Product Change Notice (PCN)

PCN Number: PCN-0451165R-01

Product(s) Affected: *PJ-041H*

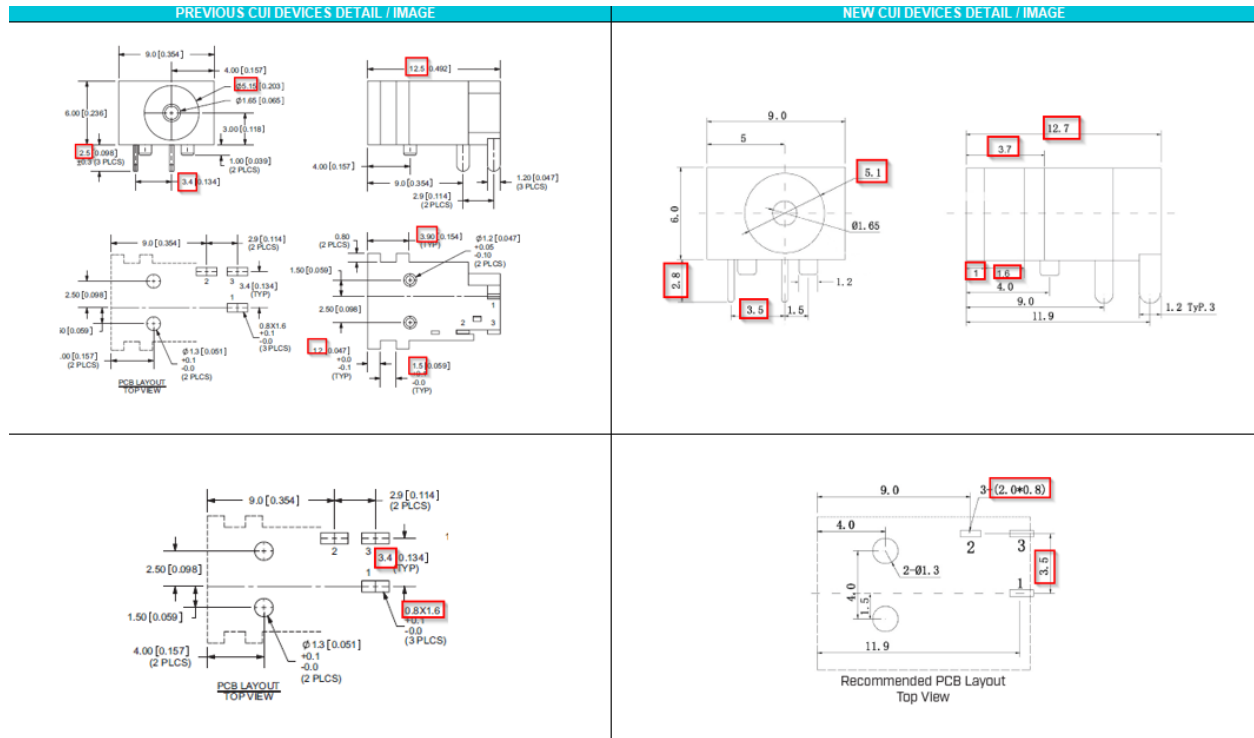
Description of Change: *Mechanical, electrical, and material changes as shown below:*

MATERIAL	PLATING
center pin	brass	silver
terminal 1	brass	silver
terminal 2	copper alloy	silver
terminal 3	brass	silver
plastic	PA66

DESCRIPTION	MATERIAL	PLATING/COLOR
center pin	brass	silver
terminal 1	brass	silver
terminal 2	C5191 phosphor bronze t=0.30	silver
terminal 3	C5210 brass t=0.30	silver
housing	PAB6 (LJL94V-0)	black
